THE MEDICAL CENTER OF AURORA

CT / X-RAY INSTALLATION

City of Aurora Building Division
Project: *New X-ray and remodel for CT*
Address: *REV-1501 S POTOMAC ST*
Occupancy Group: *I-2*
Construction Type: *I-A*
RSN: *1063633*
Permit: *15-1024782*

Only highlighted or clouded revisions are approved on this review. All previous comments apply.

1 P2.01 FIRST FLOOR PLUMBING PLAN

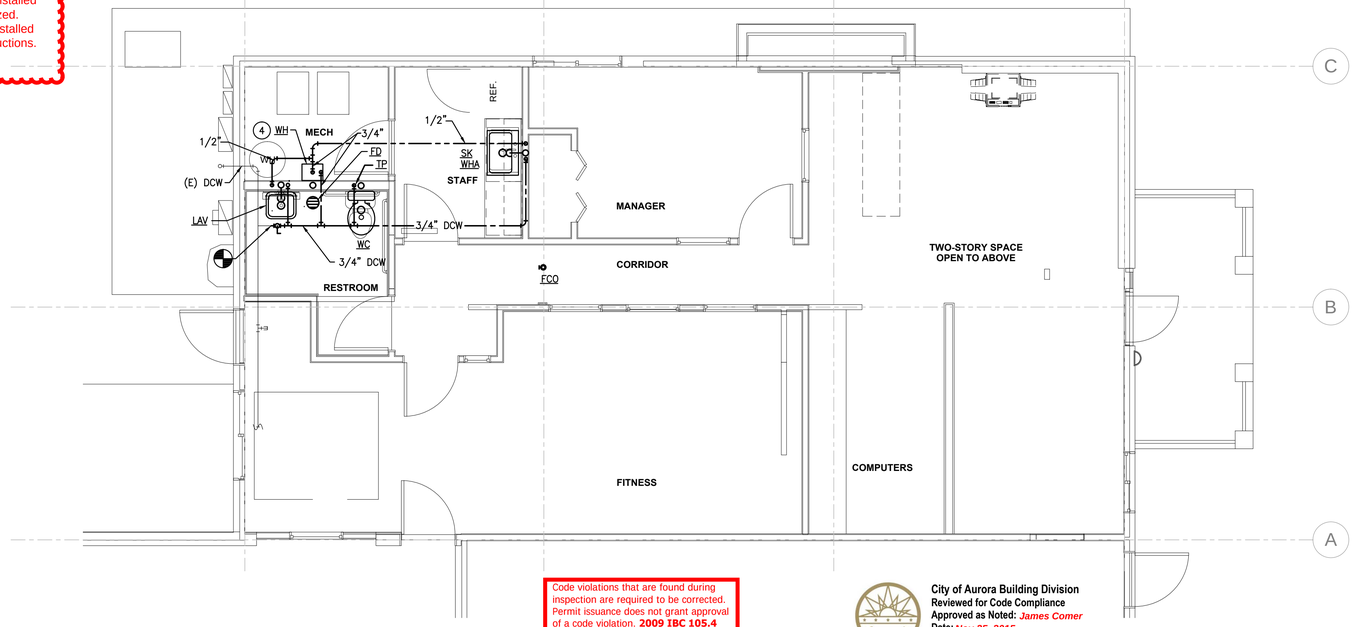
Provide drains no smaller than allowed by **2009 IPC Table 709.1 and 710.1(1)**

P2.01

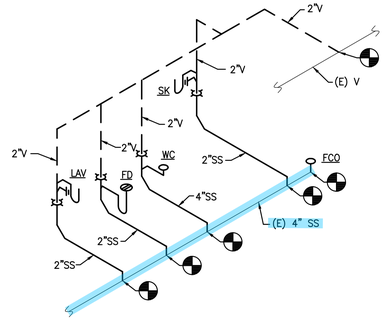
Provide drains no smaller than allowed by **2009 IPC Table 709.1 and 710.1(1)**

1 / M2.01 FIRST FLOOR MECHANICAL PLANS

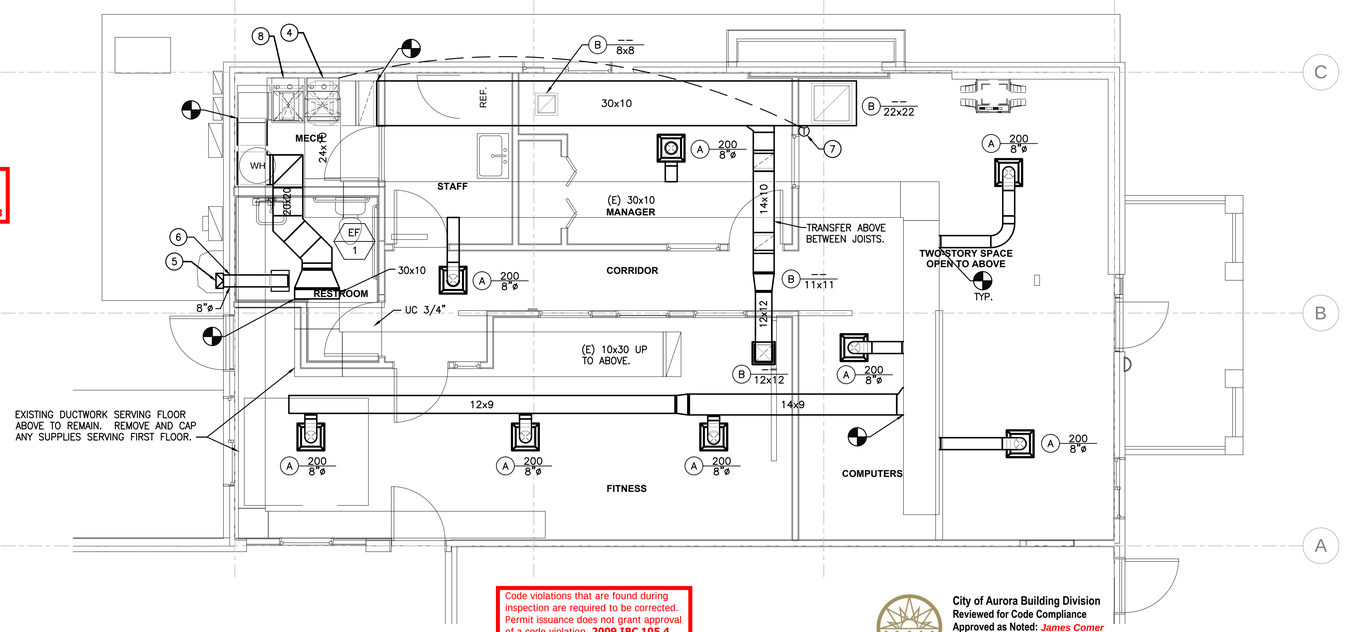
Heating system shall be capable of maintaining 68 degrees F at 3'-0" above the floor.
2009 IMC 309, IBC 1204.1, IRC R303.8

Code violations that are found during inspection are required to be corrected. Permit issuance does not grant approval of a code violation. **2009 IBC 105.4**

2 NEW ONE-LINE DIAGRAM
E1.00 N.T.S.

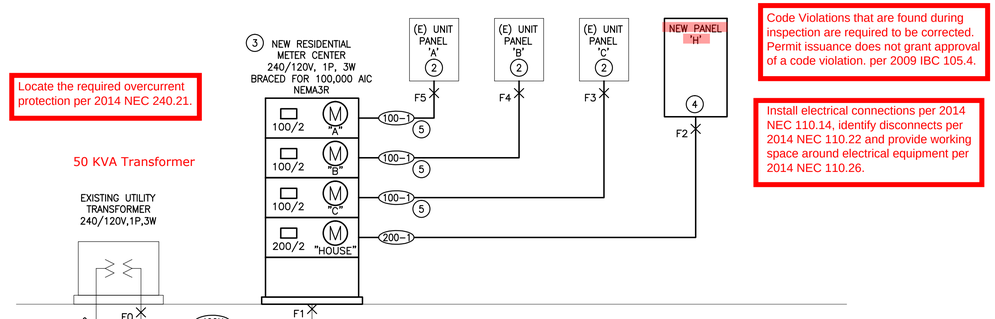
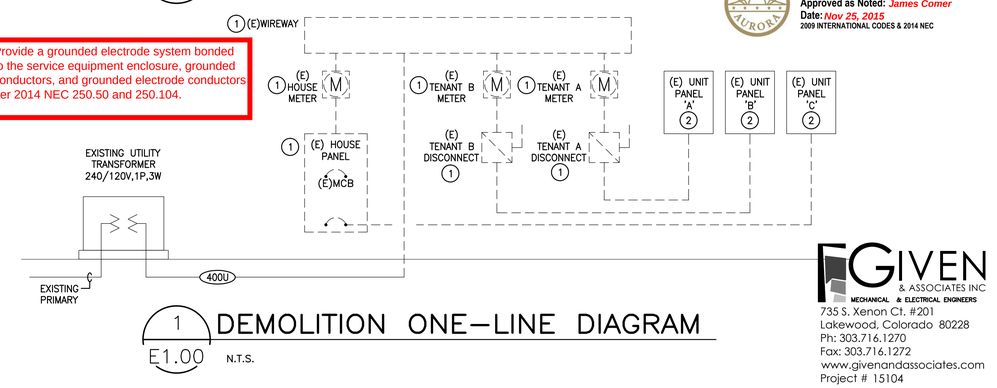
Service equipment shall be permanently and legibly marked to show the available fault current and date.
2014 NEC 110.24(A)(B).

Locate the required overcurrent protection per 2014 NEC 240.21.

Provide a grounded electrode system bonded to the service equipment enclosure, grounded conductors, and grounded electrode conductors per 2014 NEC 250.50 and 250.104.

Code Violations that are found during inspection are required to be corrected. Permit issuance does not grant approval of a code violation. per 2009 IBC 105.4.

Install electrical connections per 2014 NEC 110.14, identify disconnects per 2014 NEC 110.22 and provide working space around electrical equipment per 2014 NEC 110.26.

1 FIRST FLOOR ELECTRICAL PLANS
E2.01
4' 2' 0 4' 8'
1/4"=1'-0"

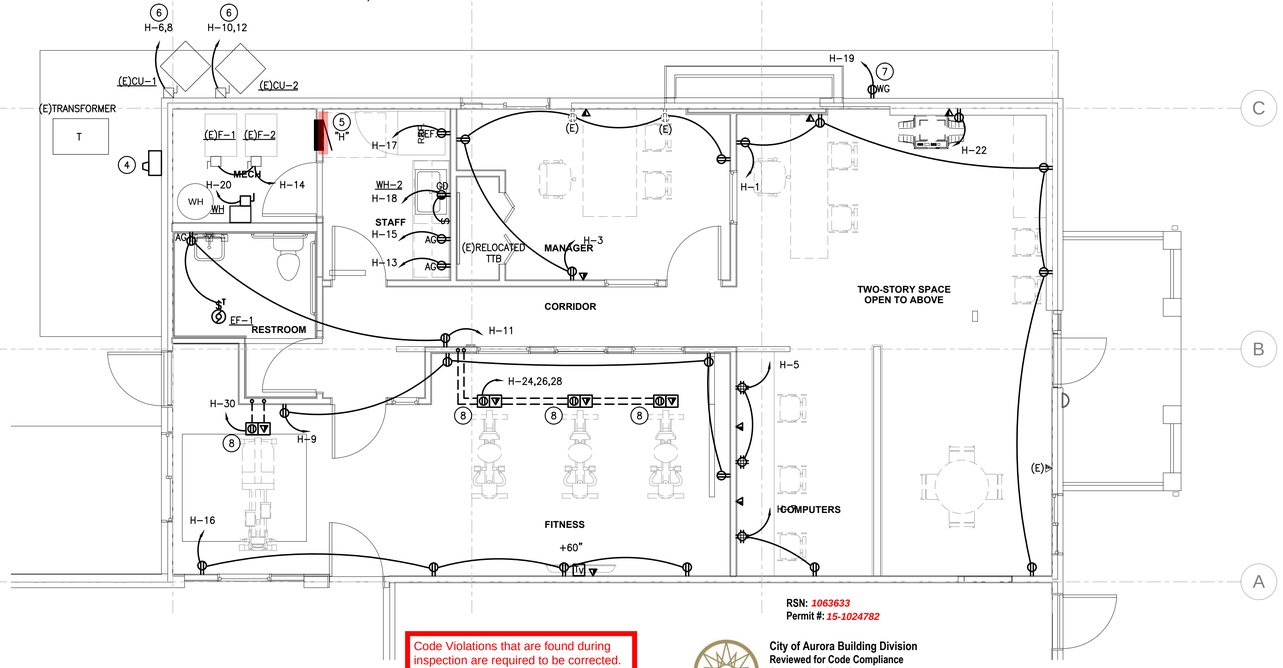
Any receptacle within 6 feet of the outside edge of a sink shall be GFCI protected. 2014 NEC 210.8 (B) (5).

1 E2.02 FIRST FLOOR LIGHTING PLAN

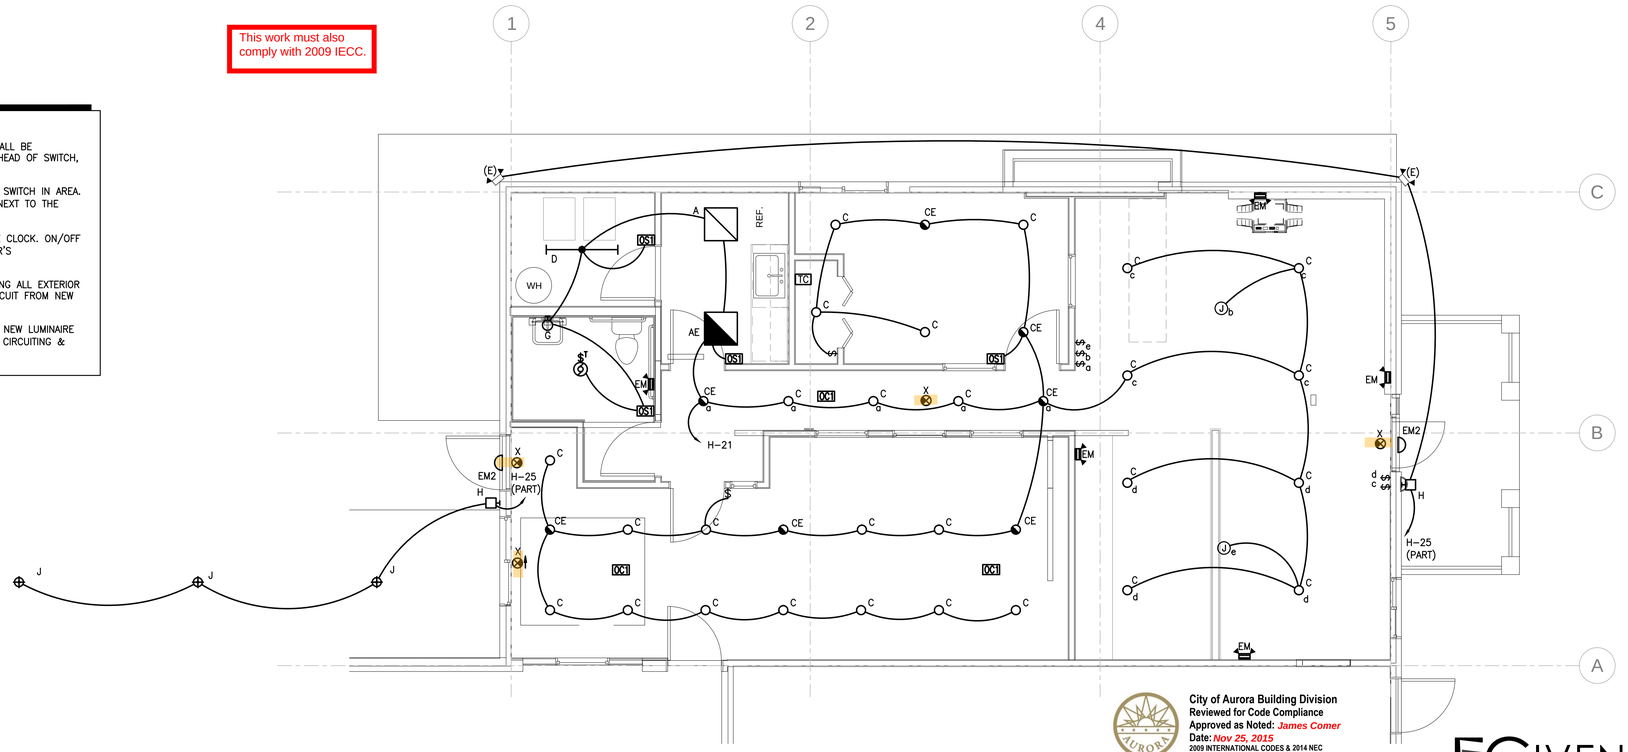
Wiring in air handling spaces must comply with 2014 NEC 300.22. Firestop penetrations per 2014 NEC 300.21. Secure and support equipment per 2014 NEC 300.11.

Code Violations that are found during inspection are required to be corrected. Permit issuance does not grant approval of a code violation. per 2009 IBC 105.4.
